PHILIPPINE HEART CENTER
East Avenue, Quezon City

SUPPLEMENTAL BID BULLETIN No. 027-2021

SUBJECT : Revisions in the Bidding Documents

PROJECT/S : 2 units Patient Call System/Call Lights - ITB No. 028.21

SECOND & FOURTH FLOOR
NURSE CALL SYSTEM LAYOUT

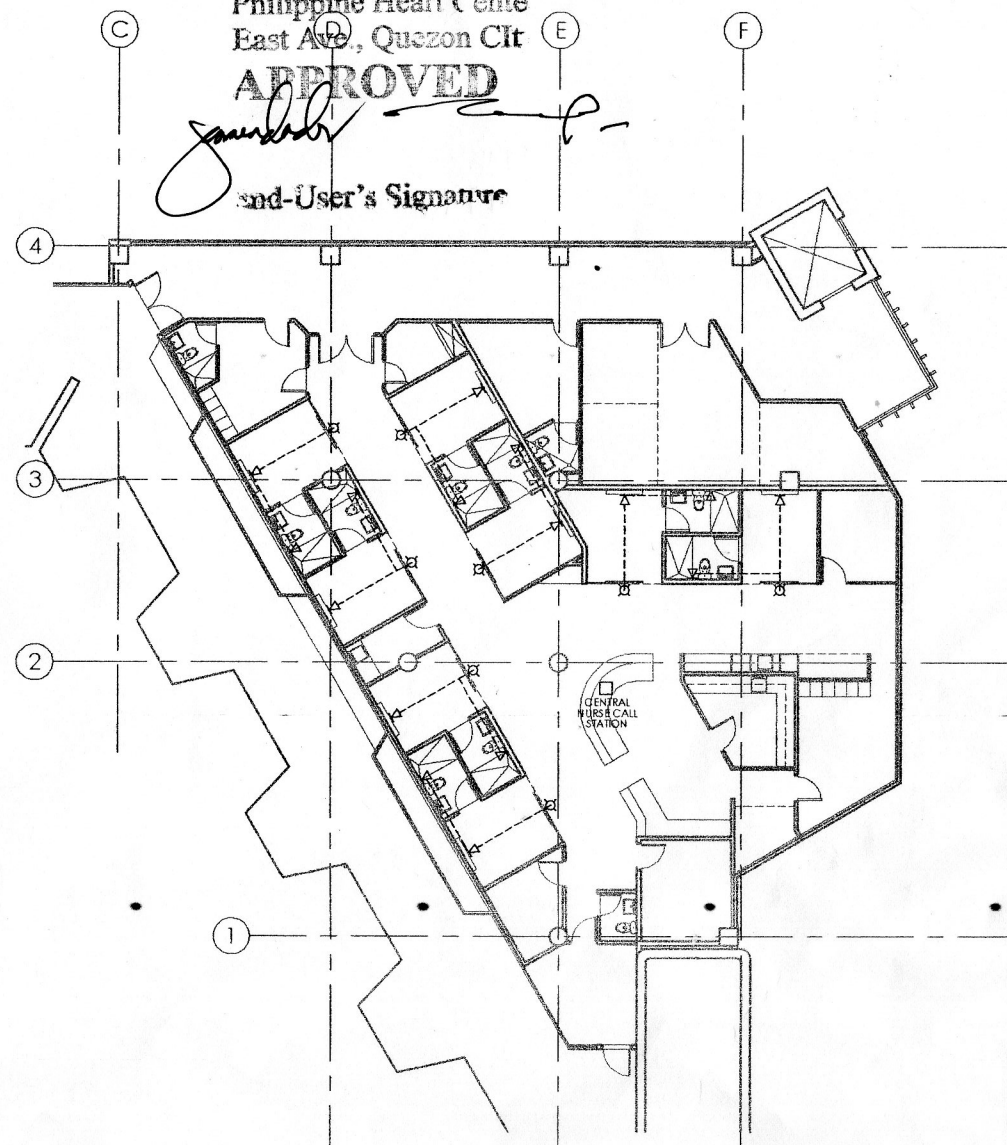
Item No./ Page No.	PHC – Technical Specifications FROM	Clarifications/Modifications (Should be read as) TO
		Additional Requirements:
		1. Delivery Period – 60 calendar days
		2. Preventive Maintenance every 6 months for 5 years
		3. Warranty – 5 years on parts and labor
		4. Availability of spare parts in the market for 5 years
		5. Floor Plan for the layout of Nurse Call System at 2 nd Flr & 4 th Flr.
